CITY PLAN COMMISSION STAFF REPORT

Project Name
City Harvest

CD-CPC-2022-00174
Rezoning from district UR to district UR Development Plan

CITY HARVEST UR PLAN AND PRELIMINARY PLAT

EXTERIOR ELEVATION - WEST RECESSED
1/16" = 1'-0" 0 12' 24' 36' **6J**

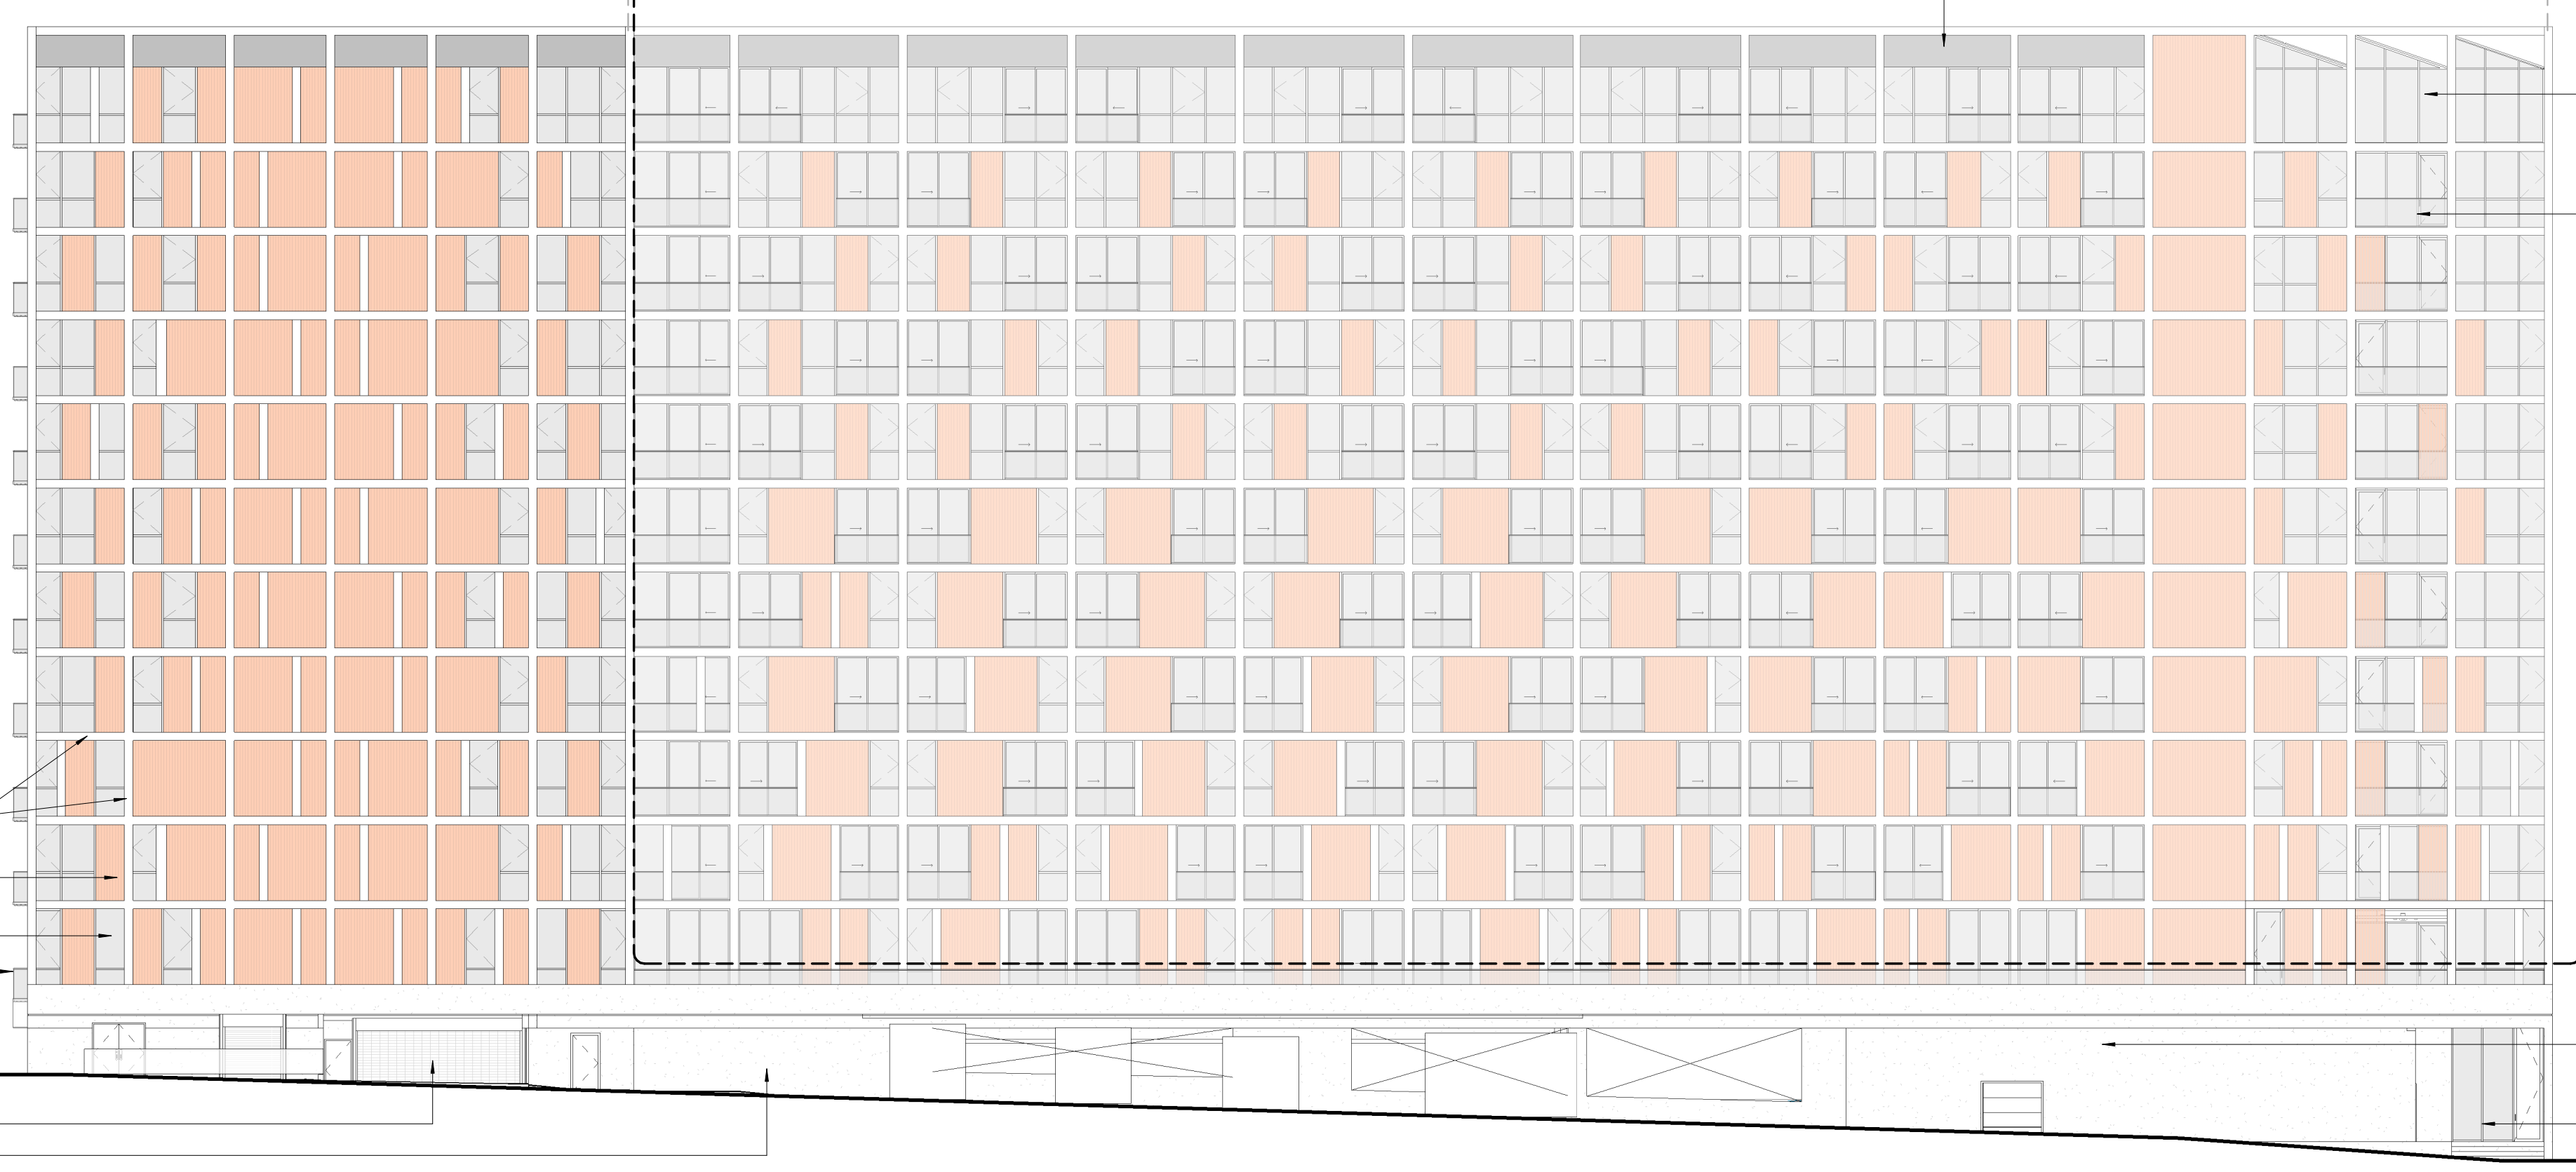
The proposed structure has a large amount of concrete on the east, west, and north elevations. The developer will need to work with staff to find appropriate alternatives for the blank spaces such as differing construction materials or public art installations at the time of UR Final Plan.

15. The developer shall continue to work with Staff to provide alternatives to the vast areas of blank concrete proposed for the first couple floors of the building. Alternatives shall be submitted at the time of UR Final Plan submittal.
